The AP1000 Nuclear Reactor Design.

By Pete Roche

November 2016

Commissioned by Radiation Free Lakeland

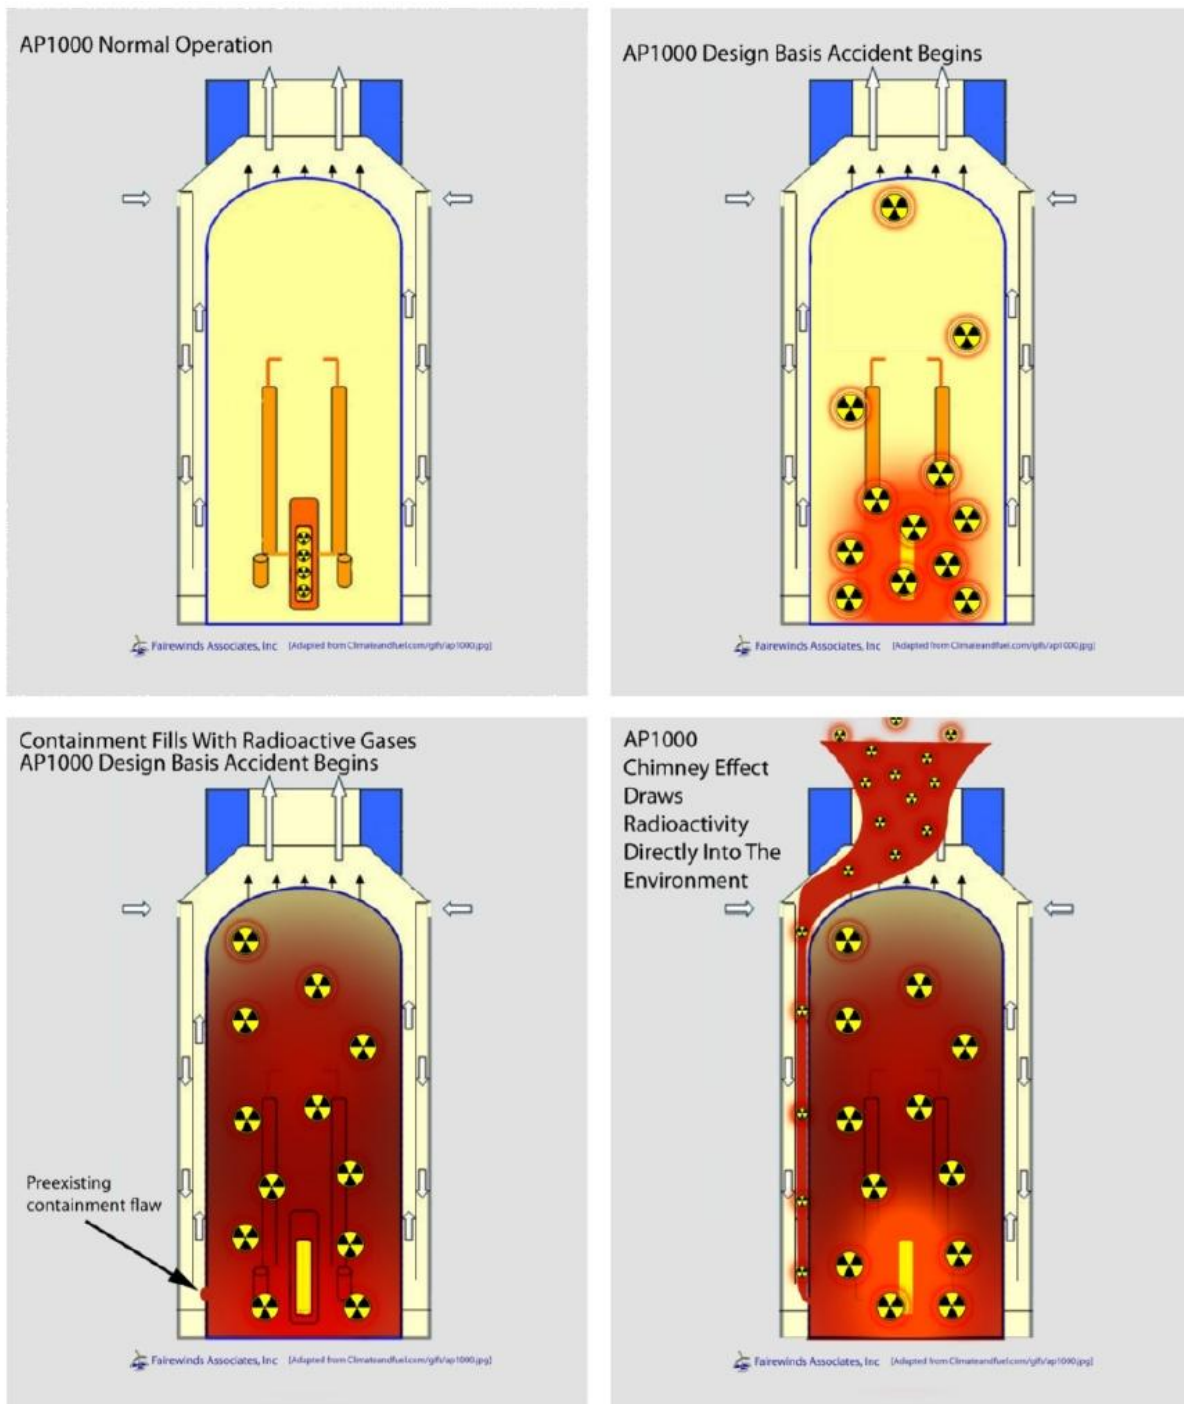
Gundersen has shown that there have been at least 40 occasions when significant corrosion and other failures have developed in containment vessels of existing reactors, and that there are at least five different ways that this might happen – such as pitting – or localised corrosion; construction debris erroneously left in the containment; failure of the thick walls due to expansion and contraction; inadequate inspections; inadequate coating.

Gundersen concludes that as a result the Westinghouse Severe Accident Mitigation Design Alternatives (SAMDA) report must be re-evaluated. If a proper SAMDA analysis was carried out it would show that filters should be required on the Westinghouse AP1000 design in order to reduce potential accident exposures.
